## 7100 Wisconsin Avenue, Site Plan Amendment No. 82013023A

Completed: June 27, 2014 **(Revised July 8, 2014)**

### Description

- Request for minor modifications to on-site public use space, off-site public amenity space, architecture, paving pattern, green roof, shift of footprint, and modifications to ADA ramps as a result of the detailed design process;
- Located at 7100 Wisconsin Avenue at the intersection with Woodmont Avenue;
- 0.58 gross tract area in the CBD-R2 Zone in the *Bethesda CBD Sector Plan*;
- Applicant: Washington Property Company;
- Filing Date: May 21, 2014

*Building footprint adjustments*

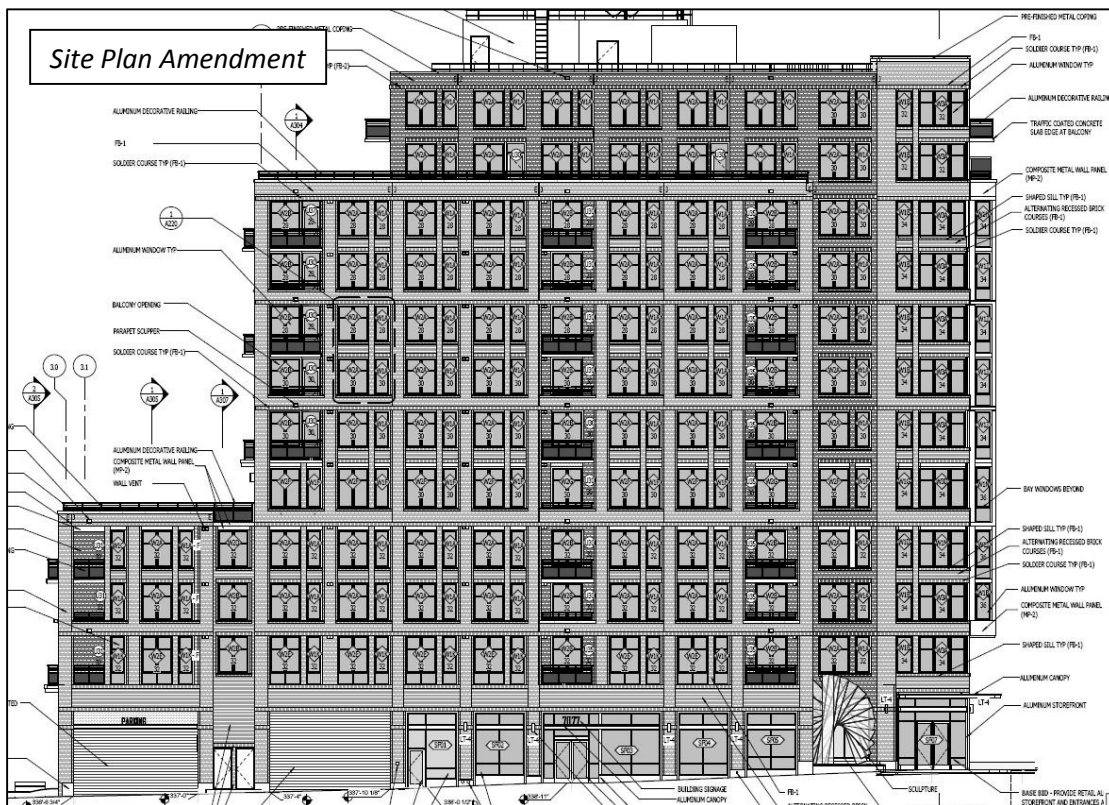
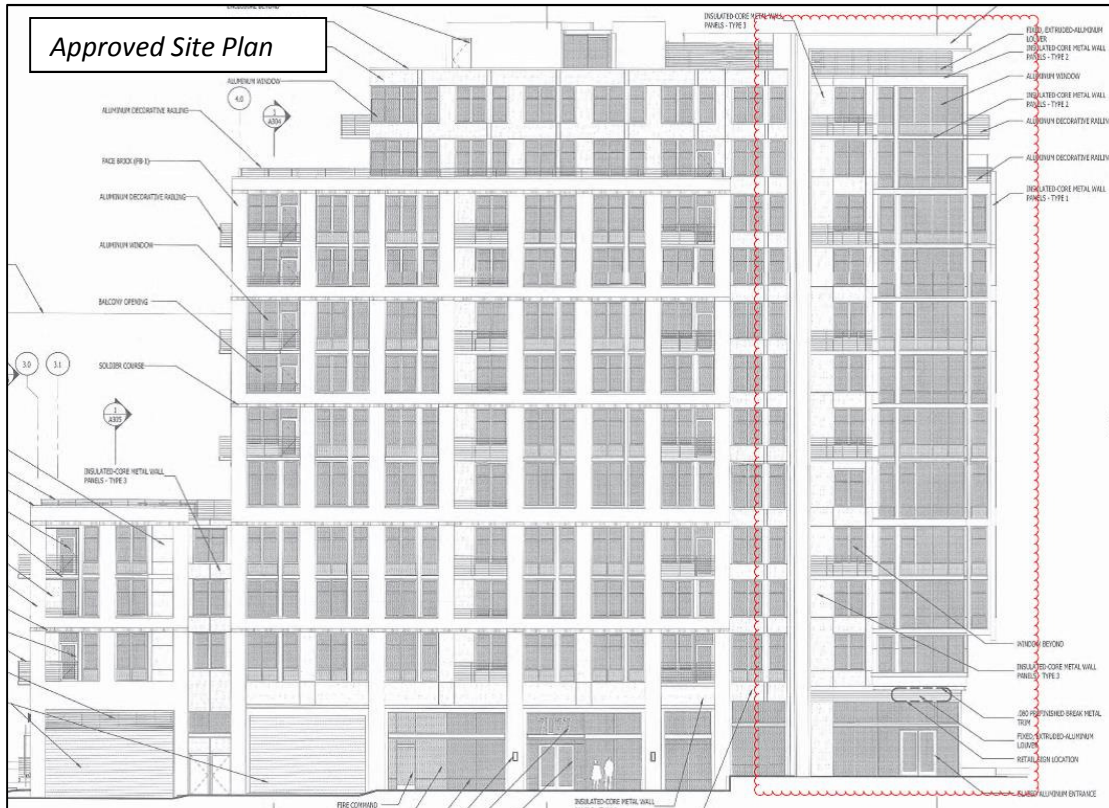
1. The east side of the building footprint has changed slightly due to design changes made as part of the engineering process. The southeast corner of the building has extended to the south approximately seven feet, and the east side of the building has extended about one foot to the east;

*Site Plan Amendment-view from corner of Woodmont and Wisconsin Avenues*

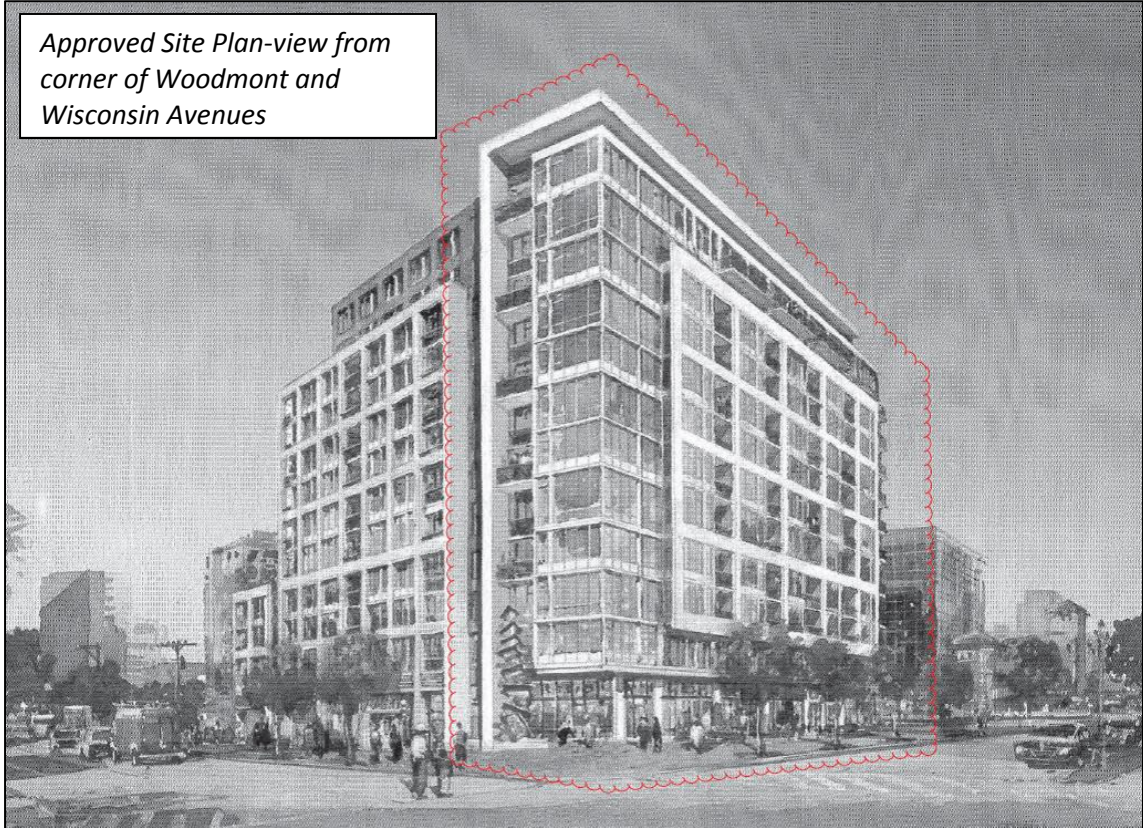
- On the east side of the building, the amount of glazing and metal wall panel has been reduced, and the amount of brick has increased;

Site Plan Amendment streetscape paving-SE corner

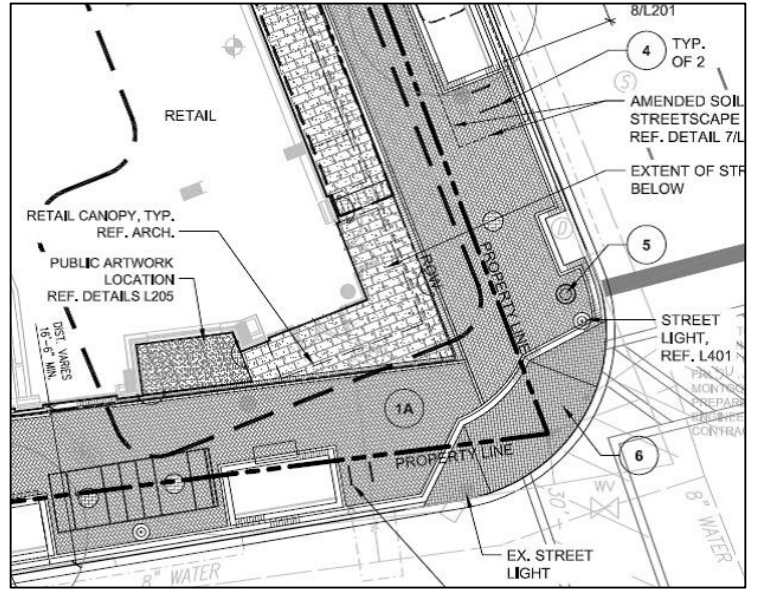
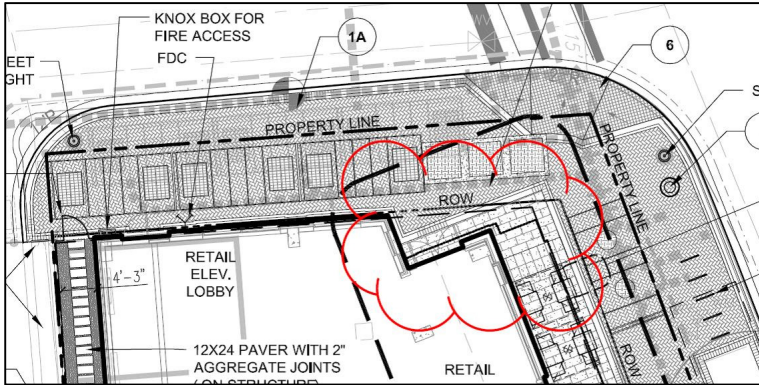
4. The streetscape paving pattern has been revised slightly due to the building footprint modifications;

*Site Plan Amendment green roof area-Level 5*

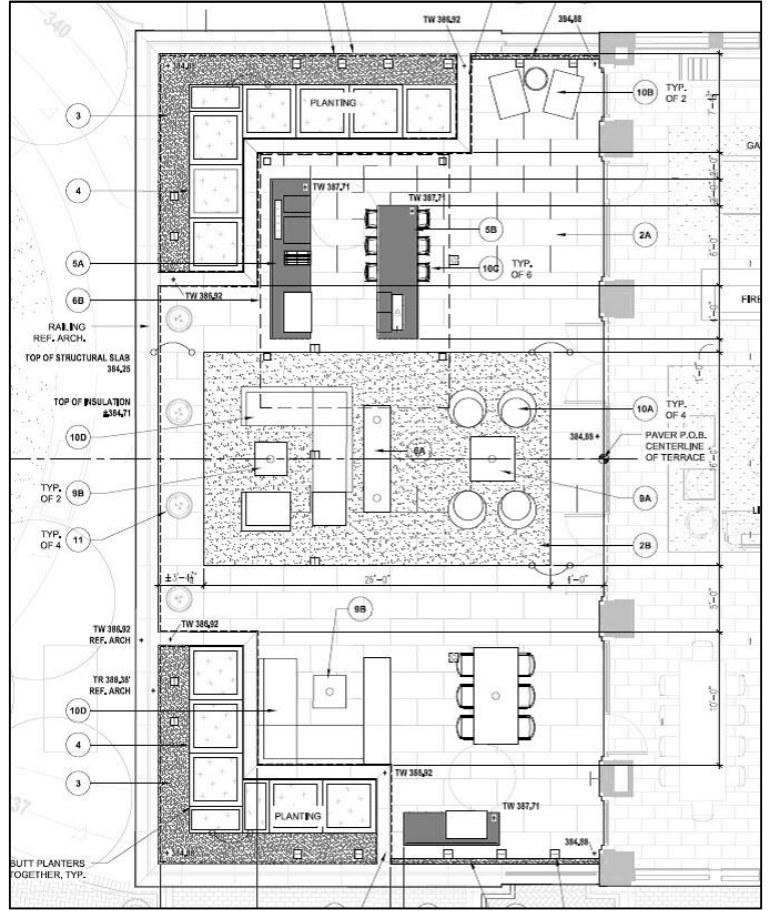
- The green roof area has been redistributed (with the planting on the rooftop amenity spaces on Levels 5 and 11 decreasing slightly because the continuous planters shown on the Site Plan have been revised to individual planters, and the remainder of the green roof requirement met through redistribution of planting to the roof that is inaccessible by tenants; and
